Dear Channel Partner,

3M Scott Fire & Safety has received a small number of reports of **previously unused** cylinder valves in the ACSi SCBA cylinders (equipped with 90° valve configuration) not flowing air when the handwheel is turned. This is the result of an incorrectly assembled cylinder valve. This Notice includes all Cylinder and Valve assemblies PN 200870-01, 200871-01, 200872-01, 200873-01, and 200874-01. Operational testing of the cylinder per the ACSi SCBA user instructions as further described below will identify this issue. Although we do not expect there to be additional cylinders with this issue in the field, we request that all ACSi SCBA owners perform an operational test of their ACSi SCBA cylinder and any spares in accordance with the procedure outlined on page 13 of the Operating and Maintenance Instructions provided with the device (PN 595207-01) and in **Figure 1**.

Figure 2 (Incorrect)

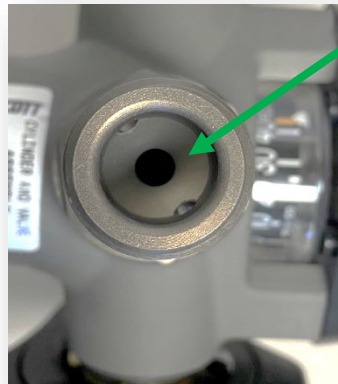
WARNING: Be sure the cylinder is connected to the ACSi SCBA before opening the handwheel, per the user instructions. If, upon opening the handwheel the remote gauge needle does not indicate any pressure, please remove the cylinder from service. Repeat this test with any unused or untested cylinder assemblies. An incorrectly assembled ACSi SCBA cylinder valve can also be identified by inspection of the threaded outlet. This inspection should be conducted on any spare cylinder valves. **Figure 2** below (page 2) shows an incorrectly assembled cylinder valve (note presence of silver ball check in the port). **Figure 3** (page 2) shows a correct outlet (no ball check present in port).

Any cylinder removed from service as a result of the inspection described above should be returned to 3M Scott for replacement. Please contact 3M Scott Fire & Safety Technical Support for an RMA at scotttechsupport@mmm.com and reference User Safety Notice SN05102021.
